License No. 21-32816-01 - Request for Additional Information – Mail Control Number 579287

NRC Amendment Questions

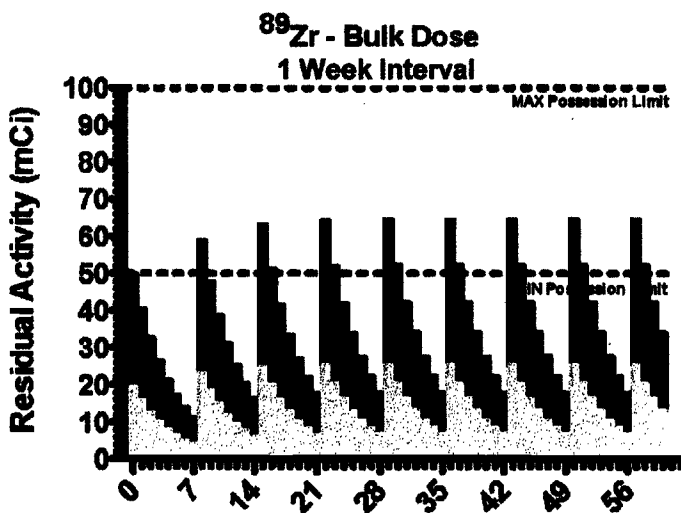
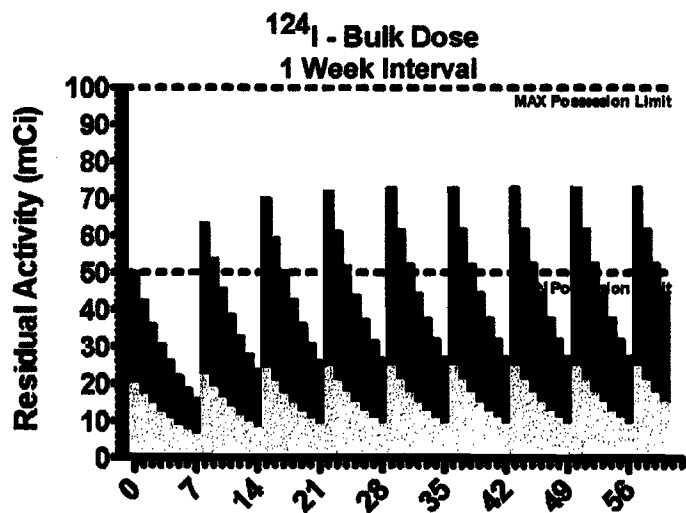
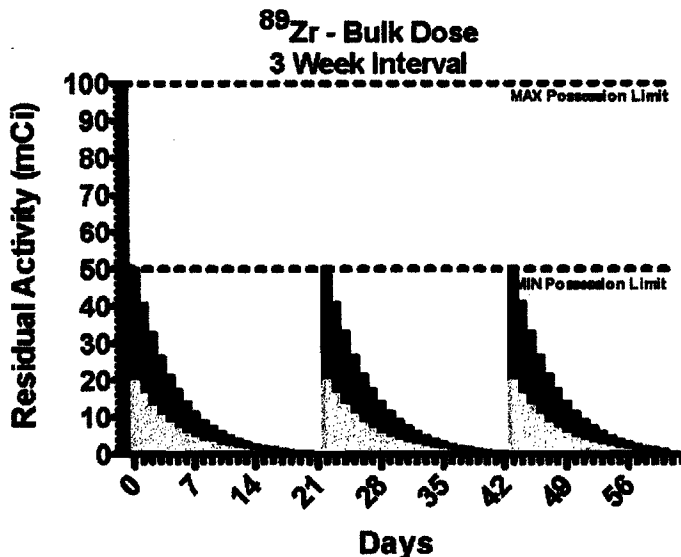
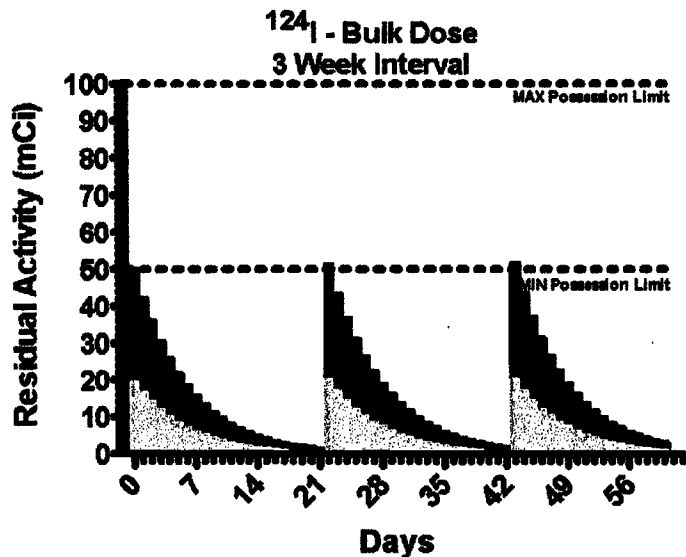
Following up from our phone conversation this morning, I am attaching 3 slides that were prepared by a colleague at Molecular Imaging prior to filing our current license amendment request. I believe the additional information you requested is adequately addressed in his slides.

- Description of the storage area for solid waste and carcasses for I-124 and Zr-89
- Expected average isotope per study (day): 20mCi (mice) - 50mCi (rats)
- Dose per animal (Zr-89 and I-124)
 - Mice: 0.2 mCi/animal
 - Rats: 0.5mCi/animal
- Number of studies per month
 - Short term: 1 per isotope
 - Long term: 4 per isotope

Attenuation Calculations

Thickness	Half Layers	Attenuation	Thickness	Half Layers	Attenuation
2 inch	10.26	99.92%	7.06	99.2%	
1 inch	5.13	97.1%	3.53	91.3%	
0.5 inch	2.57	83.1%	1.76	70.6%	
0.25 inch	1.28	58.9%	0.88	45.7%	
	0.81	42.9%	0.56	32.0%

Thickness	Half Layers	Attenuation	Thickness	Half Layers	Attenuation
2 inch	9.94	99.90%	4.58	95.81%	
1 inch	4.97	96.3%	2.29	89.9%	
0.5 inch	2.49	82.1%	1.14	54.8%	
0.25 inch	1.24	57.7%	0.57	32.7%	
	0.78	41.9%	0.36	22.1%

Thickness	Half Layers	Attenuation	Thickness	Half Layers	Attenuation
2 inch	6.30	98.73%	5.63	97.98%	
1 inch	3.15	88.7%	2.82	85.8%	
0.5 inch	1.58	66.5%	1.41	62.3%	
0.25 inch	0.79	42.1%	0.70	38.6%	
	0.50	29.1%	0.44	26.5%
